Planning Board

Subject: PD-03-23: A Planned Development District - Preliminary Development Plan for Morganton Park South Phase 3 Commercial/Retail; Applicant: Midland Atlantic Properties; Bob Koontz of KoontzJones Design PLLC, Authorized Agent; Property Owners: Morganton Road Enterprises, LLC, Robert W. Van Camp and Julie M. Van Camp, Trustees of the Robert W. and Julie M Van Camp Living Trust

Date: August 24, 2023

DATE: 07-10-2023
DESIGNED BY: REK
DRAWN BY: PJS
CHECKED BY: REK
SCALE: 1" = 60'-0"
PROJECT #: KID23040
SHEET NUMBER:
L-1.1

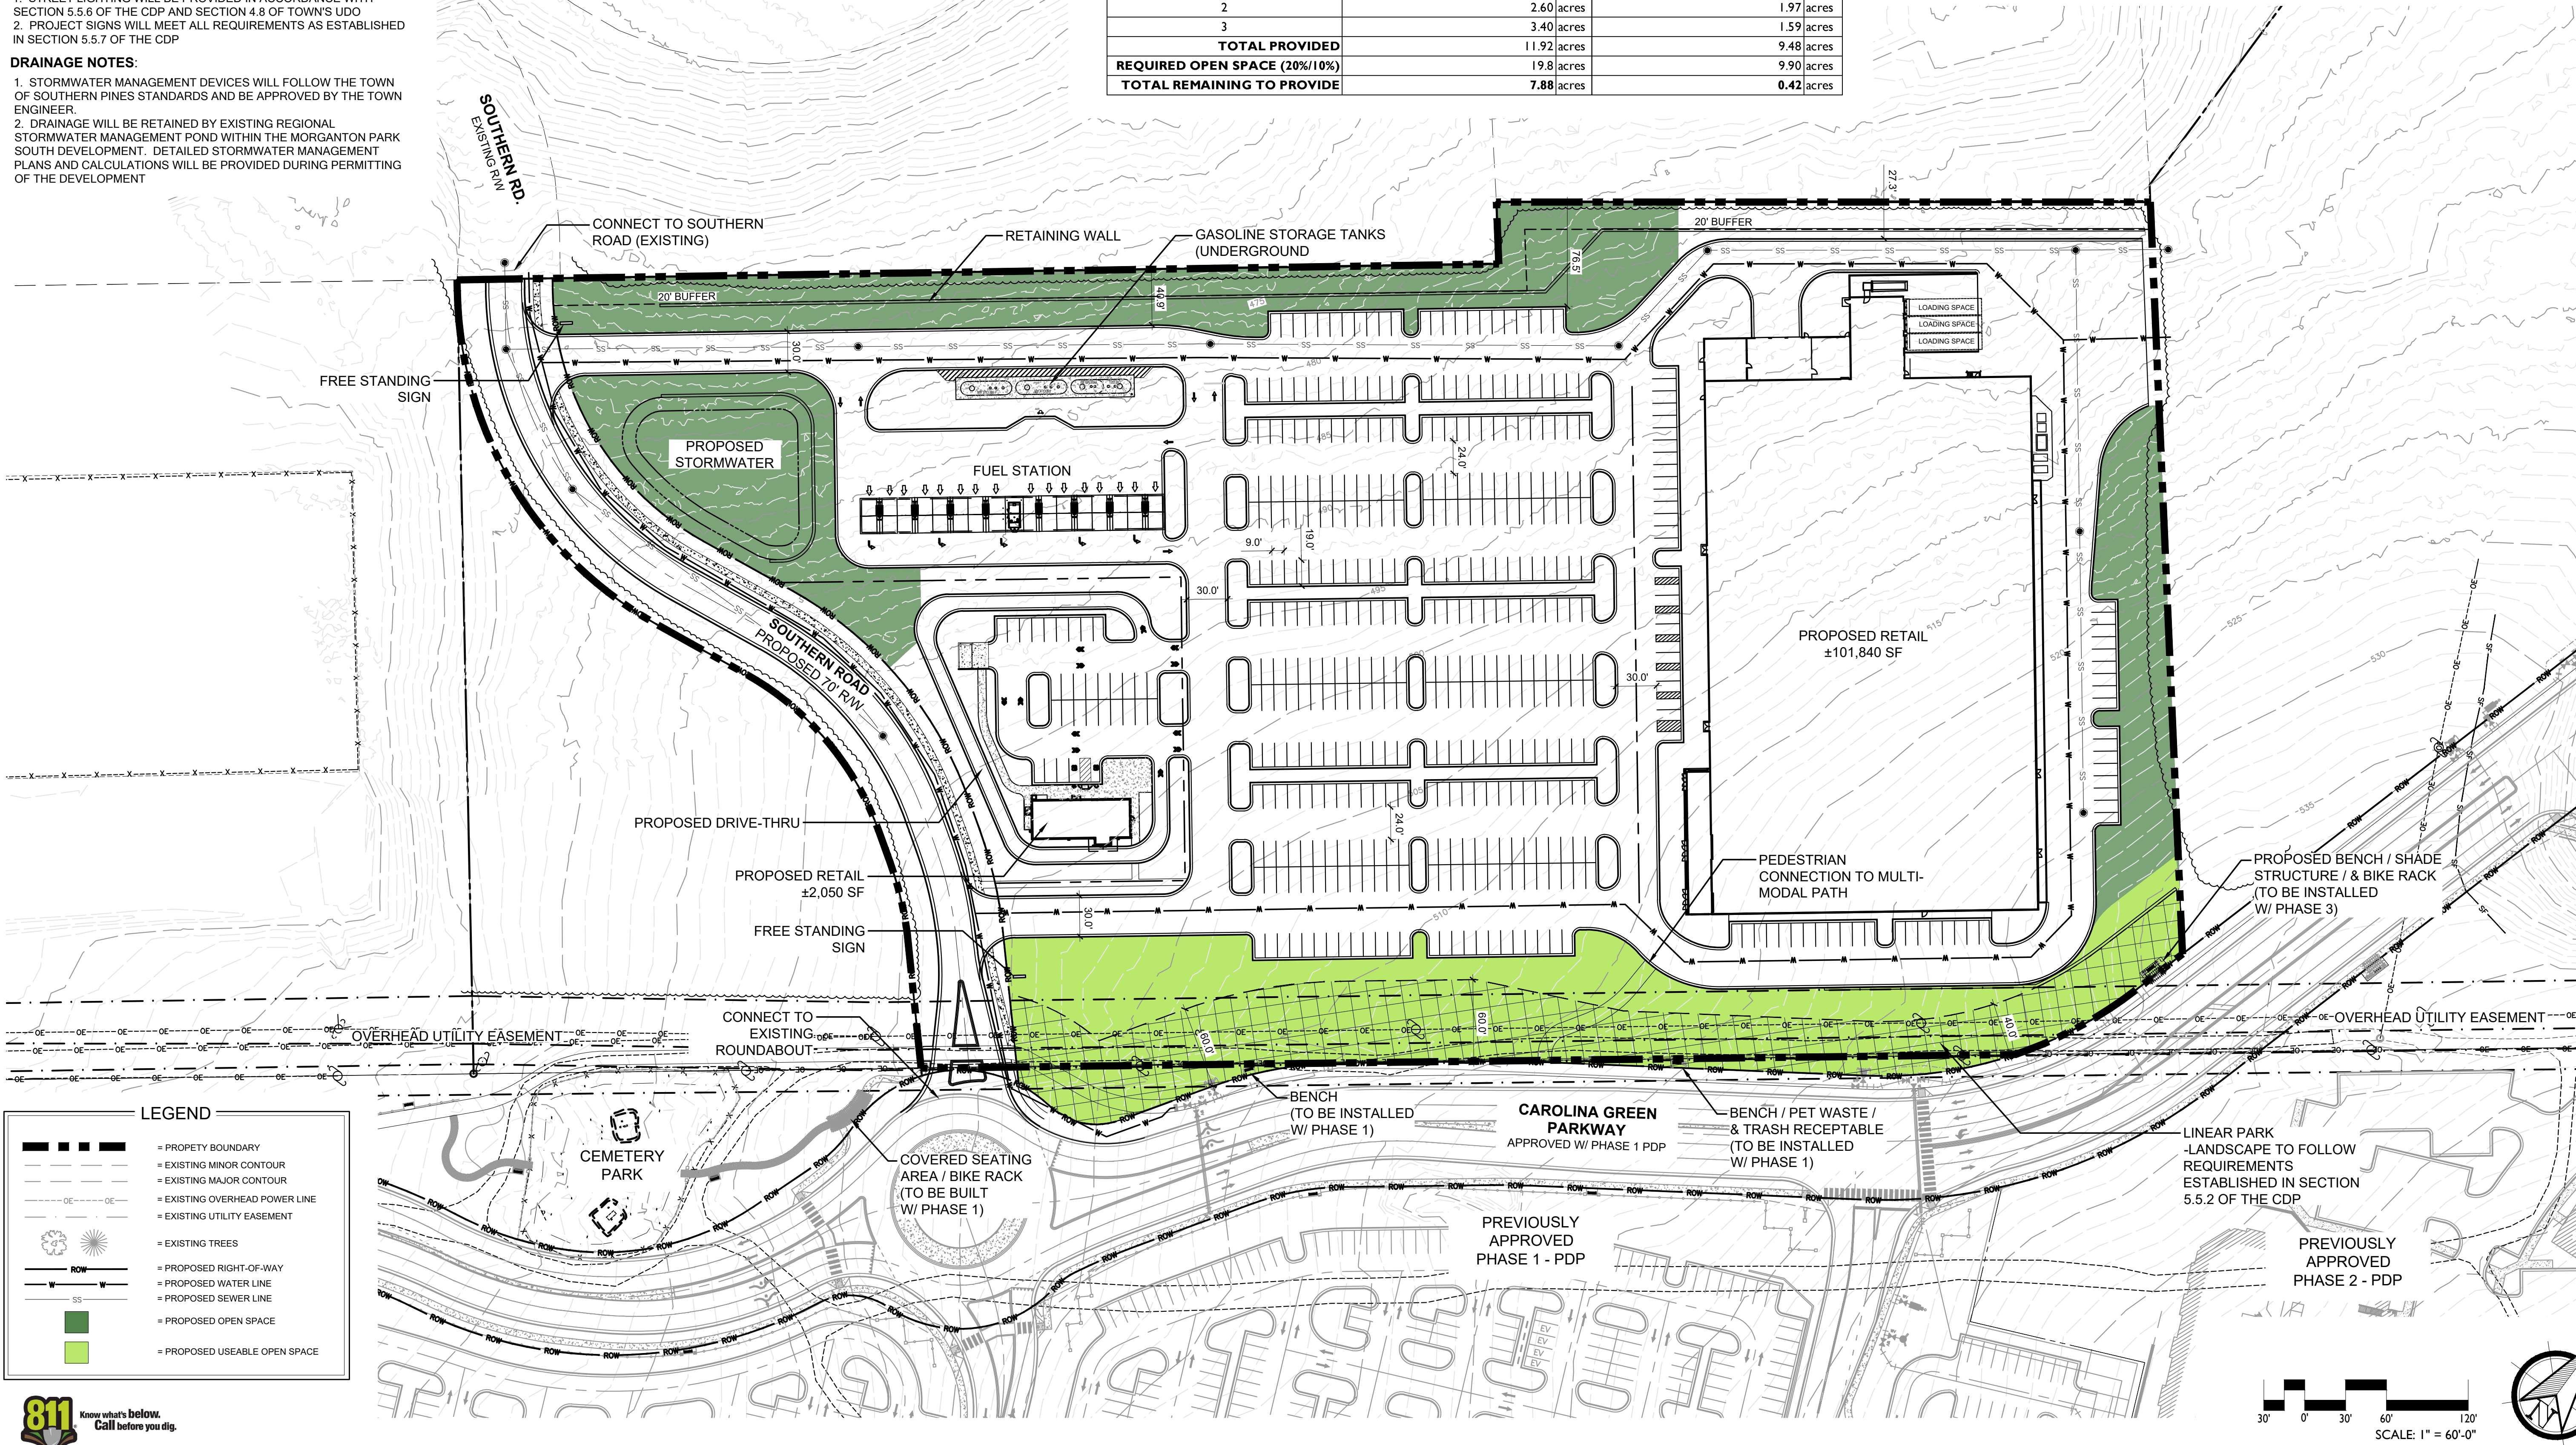
The Town Engineer, James Michel, had found three issues. First, there should be a pedestrian connection between the smaller drive-through restaurant (i.e., Starbucks) and the sidewalk. The applicant corrected this omission in their August 10, 2023, updated Sheet L-1.1 (i.e., **Attachment 3**) submittal. Second, Mr. Michel has concerns about the connectivity of utilities between this phase and future, adjacent phases. He would like the applicant to address looping of current water lines into future phases as well as clarification on whether or not the sewer line will be stubbed out in order to connect CDP Phase 7 development, which will be necessary due to technical grading issues along the Carolina Green Parkway. The applicant added water and sewer line stub outs in their August 10, 2023, updated

Sheet L-1.1 (i.e., **Attachment 3**) submittal. Lastly, the geometry of the connection between Southern Road and the Carolina Green Parkway at the roundabout is problematic and will need to be approved by the Town Engineer during site plan review. The applicant responded to this concern on August 10, 2023, stating “The design team will work with engineering staff to provide a suitable roundabout design during the site plan design/approval phase of the project.” This is acceptable to the Town Engineer.

The Phasing section of the CDP states that a conceptual utility design plan is required for the PDP process. The Technical Review Committee wanted to see water and sewer line stub outs for CDP Phase 7, which were added by the applicant to Sheet L-1.1 (i.e., **Attachment 3**) and received by staff on August 10, 2023.
